City of Culver City

VOLUME 1 TABLE OF CONTENTS

Culver City, California ADA Self Evaluation and Transition Plan

Facility Barrier Assessment Report

Comment **BHP-01** **Priority:2** **Estimated Direct Cost:** \$250 **Contractor**

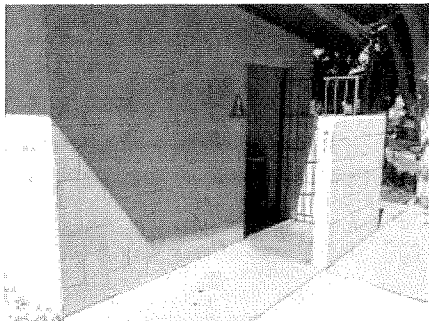
Item Description: Approach and Entrance
Exterior Access Route
Width

The route is less than 48 inches wide.

Remove obstacles to create a minimum 48 inch wide circulation path.
Widen the gate posts.

Code References: CBC 11B-403.5.1

Ramp ID: R-002 Priority: 2 Estimated Direct Cost: \$4,020 Status: Noncompliant

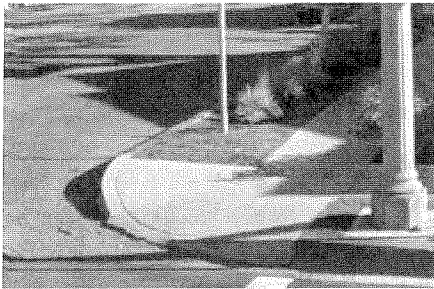
Ramp Landing 4 ft
Cross Slope 0.2 %
Running Slope 7.9 %
Ramp Width 4 ft

Reason for Noncompliance
A Detectable Warning Surface is Not Provided

Recommendation
Demolish and dispose of existing ramp and materials. Replace with ADA compliant curb ramp.

Ramp ID: R-003 Priority: 2 Estimated Direct Cost: \$4,020 Status: Noncompliant

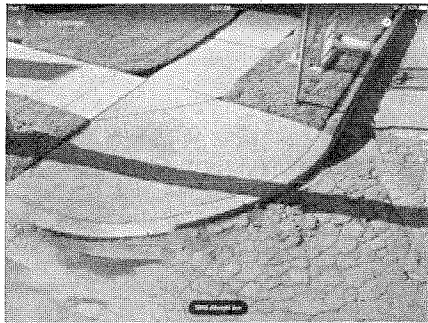
Ramp Landing 1 ft
Cross Slope 0.3 %
Running Slope 7.9 %
Ramp Width 4 ft

A 3 ft Level Landing is Not Provided
A Detectable Warning Surface is Not Provided

Demolish and dispose of existing ramp and materials. Replace with ADA compliant curb ramp.

Ramp ID: R-006 Priority: 1

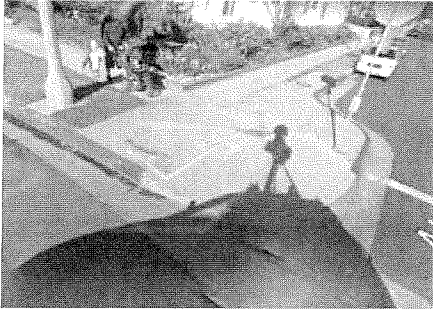
Ramp Landing 3 ft
Cross Slope 0.3 %
Running Slope 7.4 %
Ramp Width 4 ft

A Detectable Warning Surface is Not Provided

Demolish and dispose of existing ramp and materials. Replace with ADA compliant curb ramp.

Ramp ID: R-007 Priority: 2

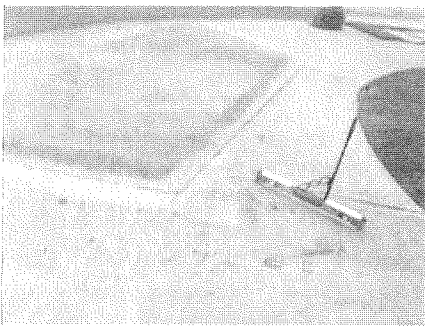
Ramp Landing 2 ft
Cross Slope 0.9 %
Running Slope 9.5 %
Ramp Width 4 ft

Reason for NoncomplianceThe Running Slope Exceeds 8.33% Grade
A 3 ft Level Landing is Not Provided**Recommendation**

Demolish and dispose of existing ramp and materials. Replace with ADA compliant curb ramp.

Intersection ID: I-21

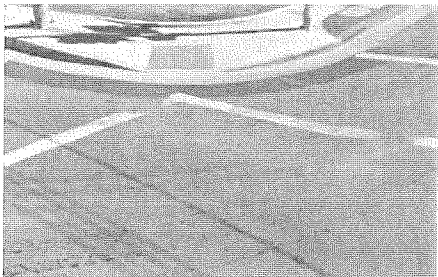
Faded Crosswalk Stripe

Ramp
Landing: = 48 in**Recommendations:**

Repaint the crosswalk lines to provide a minimum 48 inch landing space at the base of each curb ramp.
